UNITED STATES
DEPARTMENT OF THE INTERIOR
BUREAU OF LAND MANAGEMENTFORM APPROVED
OMB NO. 1004-0137
Expires: January 31, 2018**SUNDRY NOTICES AND REPORTS ON WELLS**
*Do not use this form for proposals to drill or to re-enter an abandoned well. Use form 3160-3 (APD) for such proposals.*5. Lease Serial No.
NMNM112723X

EAST BLINEBRY DRINKARD UNIT 25

Apache is requesting permission to convert this well to injection, per the attached procedure and WBD's.

Conditions of Approval

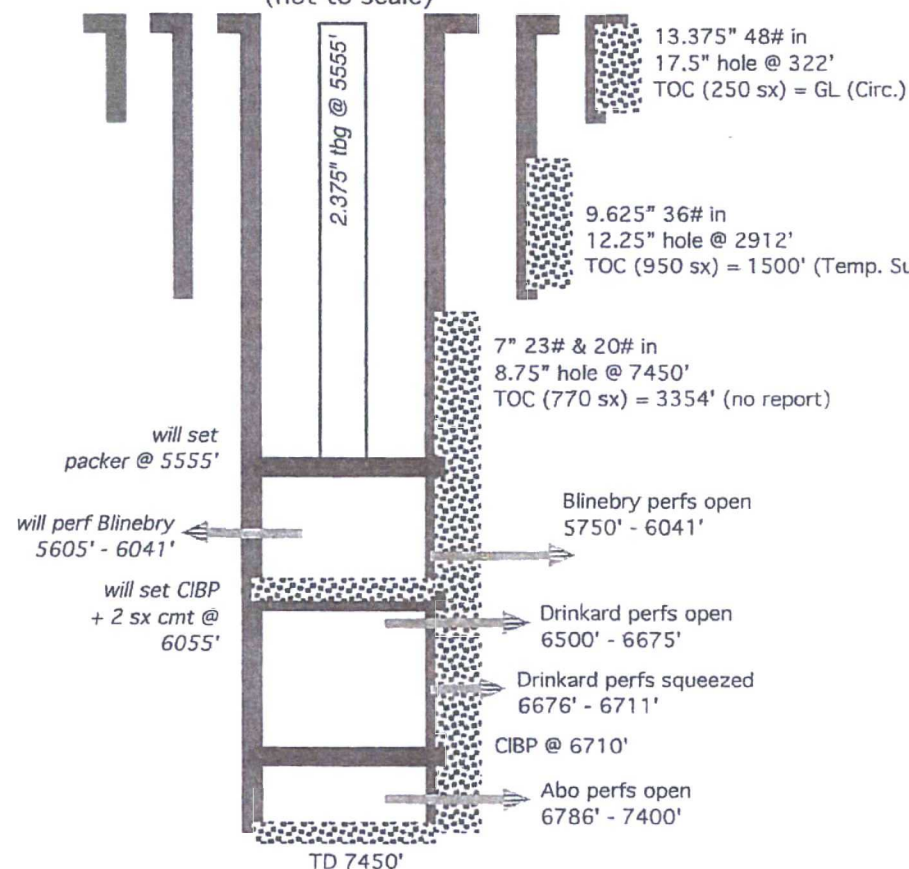
3. TIH with CIBP and work string. Set CIBP at ~6,055' and cap with ~~2 sacks~~^{35'} of Class "C" cement. *on 15 Sacks*
4. TOH with work string. PU and TIH with treating packer and work string. Set treating packer ~50' above existing Blinebry perforation. Load the casing with produced water. Pressure test the casing to 500 psig for 30 minutes. Release the pressure and packer. TOH with the work string and treating packer.
